THE RESERVE AT CORRAL BLUFFS FILING NO. 3

A PORTION OF THE EAST HALF OF SECTION 31 AND WEST HALF OF SECTION 32
TOWNSHIP 13 SOUTH, RANGE 64 WEST OF THE 6TH P.M.
EL PASO COUNTY, COLORADO

FILE NO. SF-207

Final Plat_V1.pdf Markup Summary

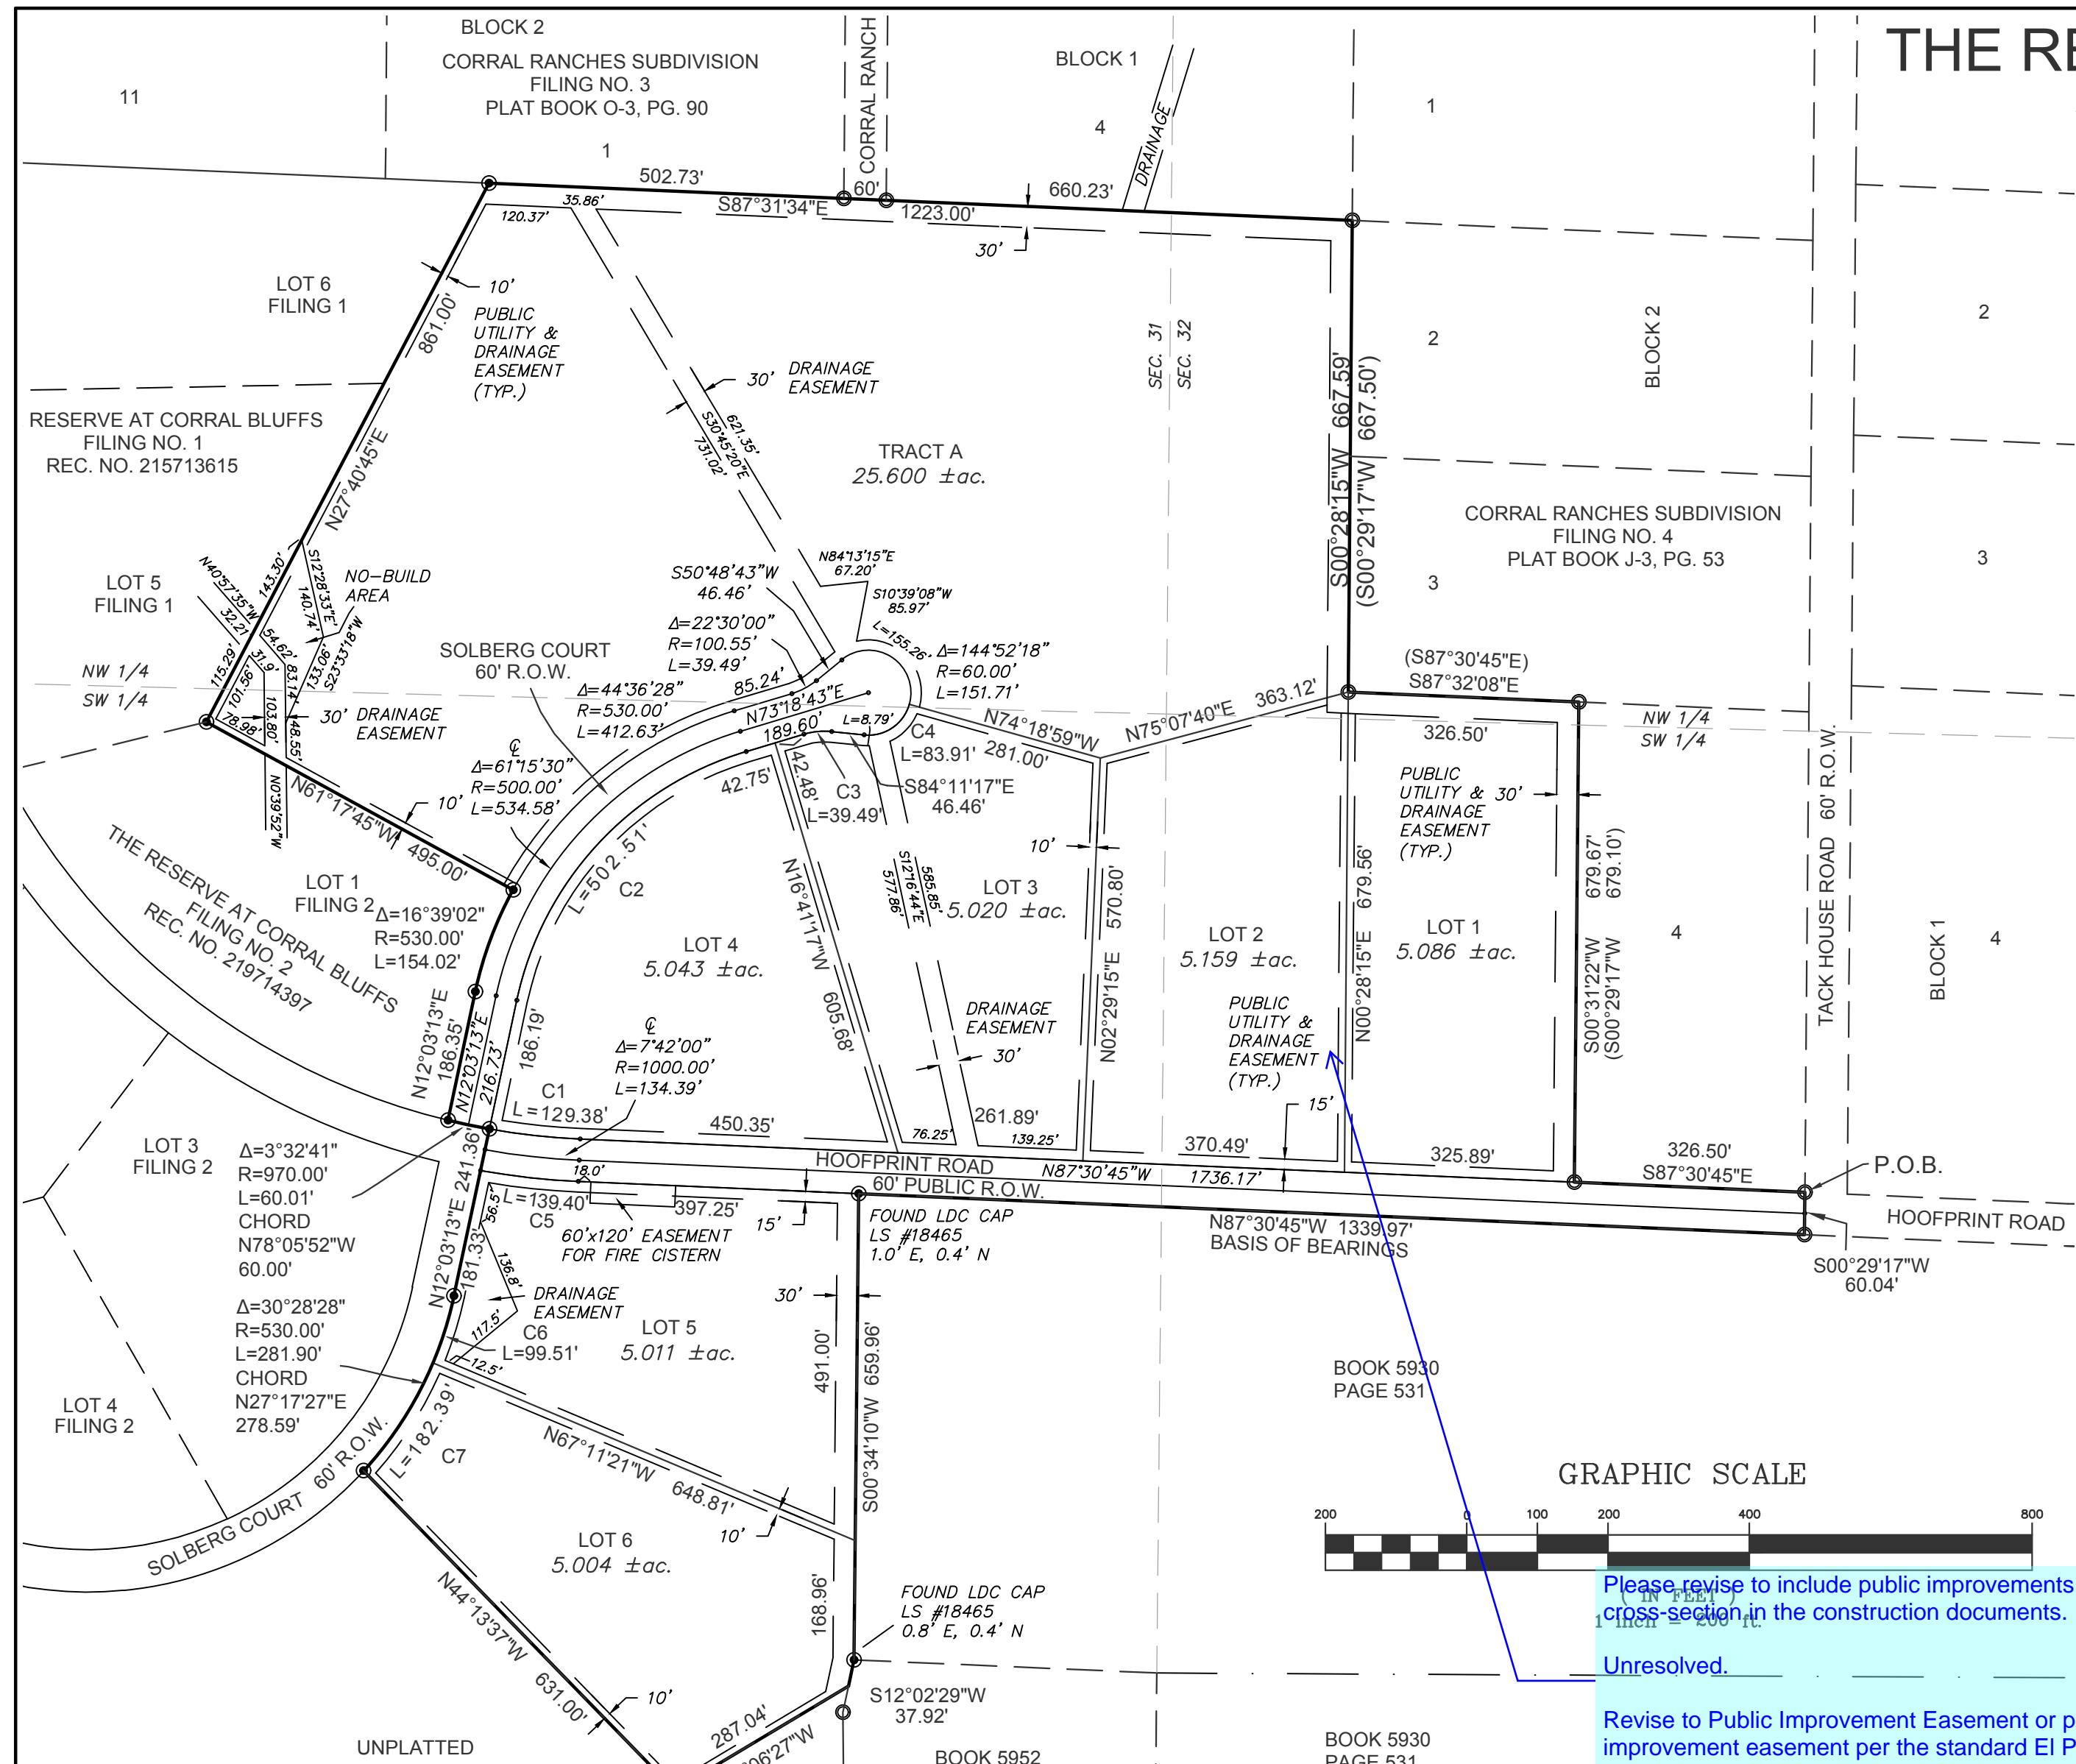
Please revise to include public improvements as shown on the road cross-section in the construction documents.

Unresolved.

Revise to Public Improvement Easement or provide a 5' Public improvement easement per the standard El Paso County rural gravel road section (detail SD_2-10). See snippet below.

Indicate the ROW for Hoofprint Road

If these are Type 3 cluster boxes, update plans and plat to meet ECM Chapter 4 Section 4.4.5.E for mailbox placement.
 "Type 3 mailbox and the pullout for the mailbox shall be located within the ROW but outside the roadway clearzone.

verify information, soils and geology report indicate impacts to Lots 1, 2, 3, 4, 6, and tract A, and areas of ponding water should be no-build areas
